STAFF RECOMMENDATION

NCPC File No. 6553

**WHITE OAK FEDERAL RESEARCH CENTER
FOOD AND DRUG ADMINISTRATION
NORTH GARAGE 1
Montgomery County, Maryland**

Submitted by the General Services Administration

FDA CONSOLIDATED CAMPUS 2002 REVISED MASTER PLAN

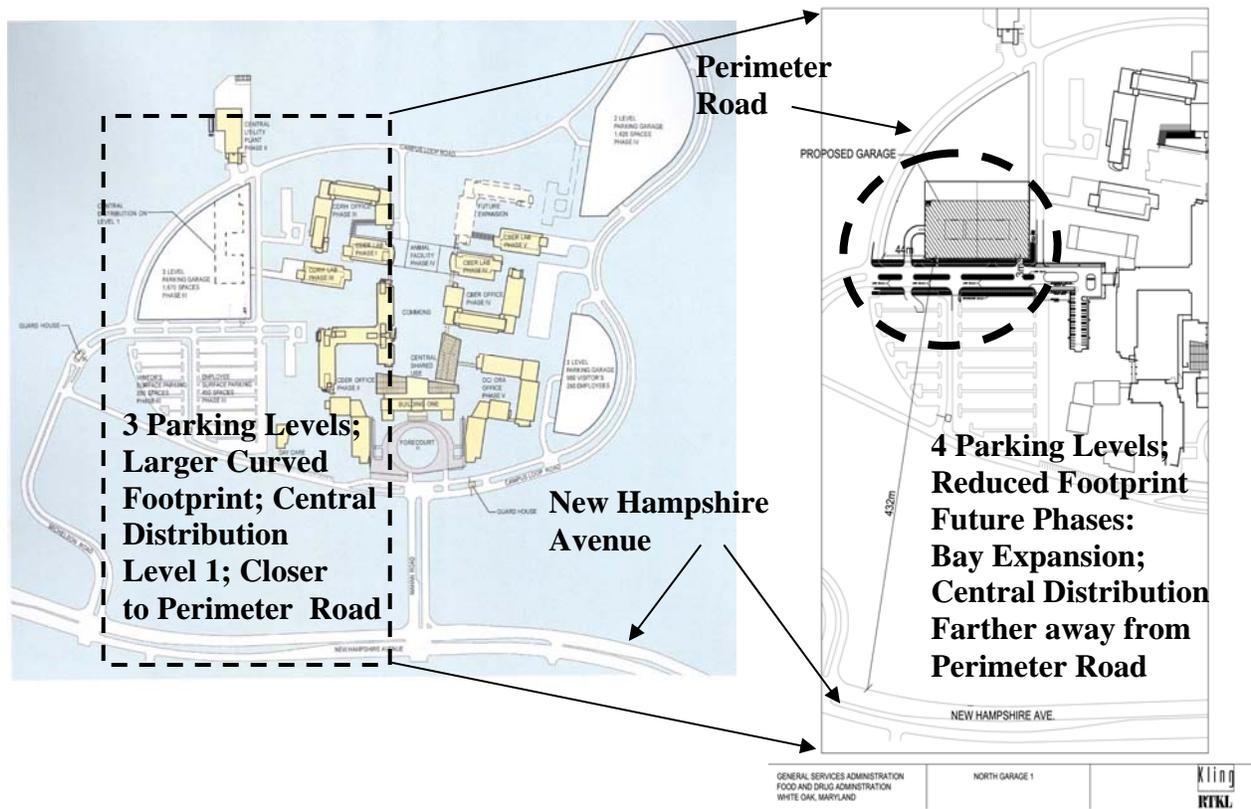
The Commission approved the revised master plan for the FDA consolidation at its June 6, 2002 meeting with the exception of the final number of parking spaces proposed for the campus. In its report, the Commission stated its expectation that prior to submission of the revised parking plan required within 9 months of full occupancy of the CDER Office Building 1, each submission for a new building at the FDA site should include a parking analysis which includes the following: the number of employees being added, the location and number of parking spaces associated with the building, and the proposed parking ratio as a result of the future building. The North Garage 1 will complete Phase III of the campus build-out and will follow the Shared Use Facility, now under construction, and the Engineering/Physics Lab, currently advertised for bid, also part of Phase III. The Life Sciences CDER Lab was completed in 2003 under Phase I, and the CDER Office Building 1 is expected to be completed in summer 2005 under Phase II. The CDER Office Building 2 has been moved forward from Phase IV to Phase III, while the Center for Devices and Radiological Health (CDRH) office building will move from Phase III to a later phase.

The Commission approved the revised master plan for the FDA consolidation at White Oak during its June 6, 2002 meeting with the exception of the final number of parking spaces proposed for the campus. This project is not consistent with phasing aspects of the revised master plan, nor with the following exception described below:

- The sequence of construction phasing has changed due to the order in which projects were funded. Therefore, this project, initially planned as part of Phase IV, is now planned to complete Phase III construction. The master plan calls for landscaping the north side of the campus to be completed at this time, concurrent with development of the north side of the campus. Shifting projects out of sequence has delayed completion of landscaping of the north side of campus until the final master plan development phase.

- The footprint has been reconfigured from curvilinear to rectangular and the area has decreased. However, an additional tier of parking has been added, up from three to four levels. The master plan states that parking will be no more than three levels.

PERSPECTIVE FROM CEDER 1 FACING NORTH

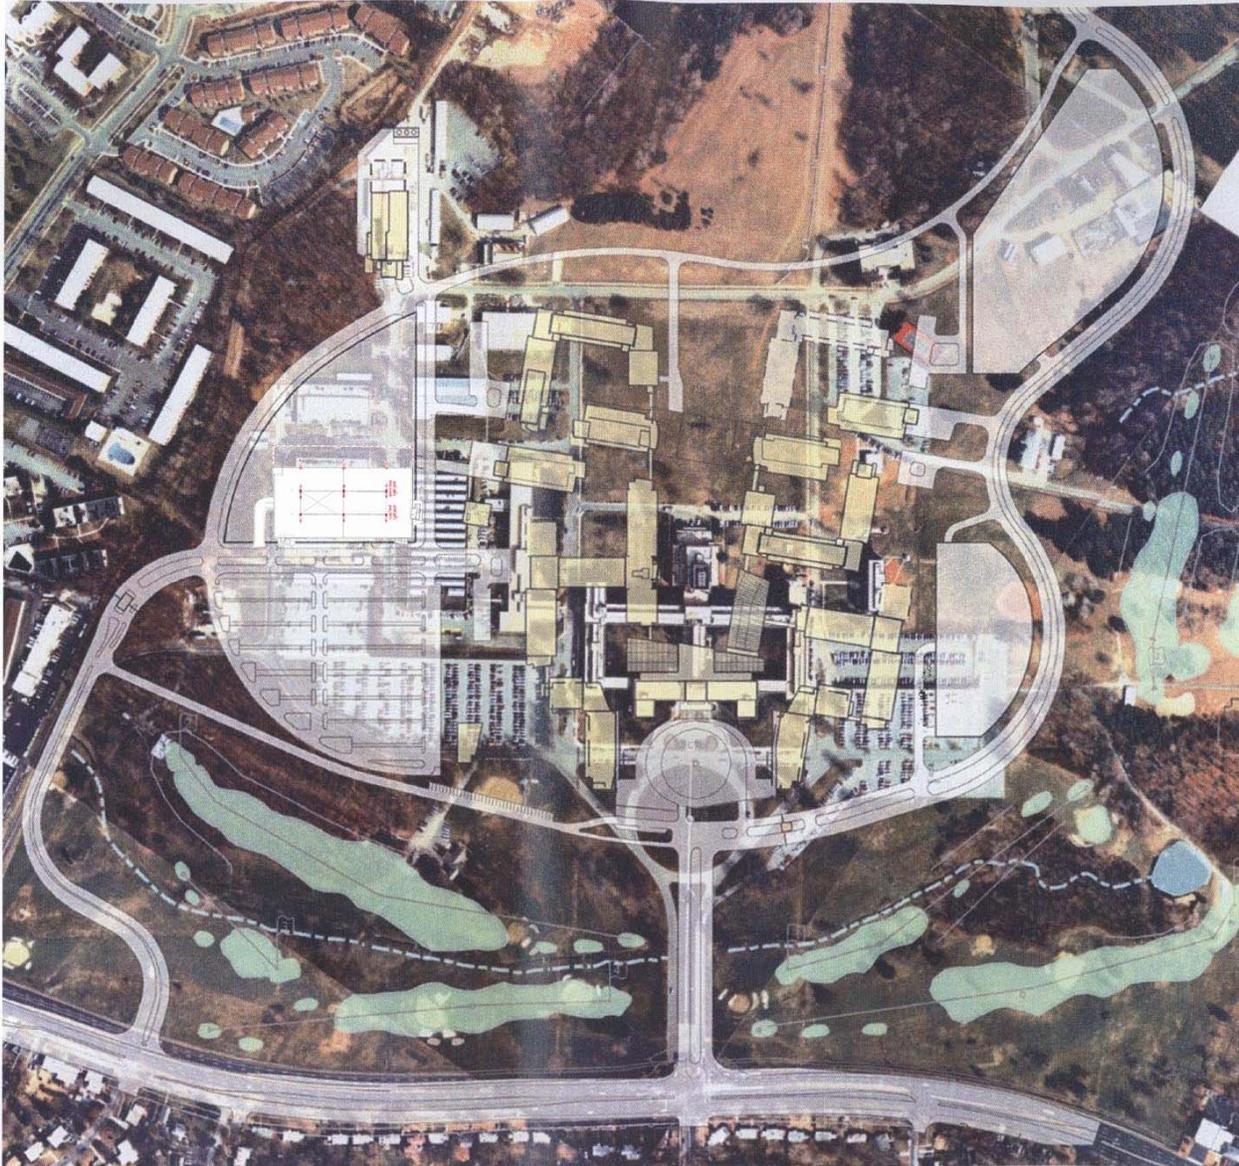
The design intent of the low brick wall is to tie the garage to the rest of the campus and to give pedestrian scale to the garage. Since the new office buildings and two historic buildings being retained have significant amounts of brick, staff agrees with this rationale. Staff, however, rejects the notion that the low brick wall base provides scale to the building. Staff expressed

concern to the applicant prior to submittal that the massive scale of the garage and vast expanse in the horizontal direction needs to be broken down in scale. The applicant remains firm in the belief that the scale of the 375 foot long elevation is sufficiently broken down by the concrete columns that appear every 23 feet from behind the aluminum panels. Moreover, the applicant believes that the elongated west elevation clad in aluminum panels serves as a background building to the future tree-lined boulevard, which, if over articulated, would compete for attention with the sculptural stair elements, and should remain neutral. Staff commends the applicant for clear and elegant articulation of the vertical circulation elements, as well as for the use of the cast in place concrete portal to articulate the vehicle entrance and to punctuate the west facade. Staff would like to see further articulation or punctuation of the facade, possibly by creating pattern through placement of the aluminum panels.

Structural materials without finishes proposed for both the east and north facades concern staff. The east elevation expresses the split across development and construction phases where a future bay will be added. Use of a cable barrier system and exposed CMU at exit stairs in lieu of a completed architectural skin on that elevation to match the surrounding permanent skin does not meet the phasing approach described in the master plan. Although not scheduled for expansion, in a similar manner, the majority of the north facade will expose the post-tensioned concrete structure and its textured surface. Design rationale for this facade is not clearly articulated in the submittal. Staff observes, however, that the north facade may receive less intense scrutiny because drivers will exit rather than approach it, and it will be partially hidden from view by
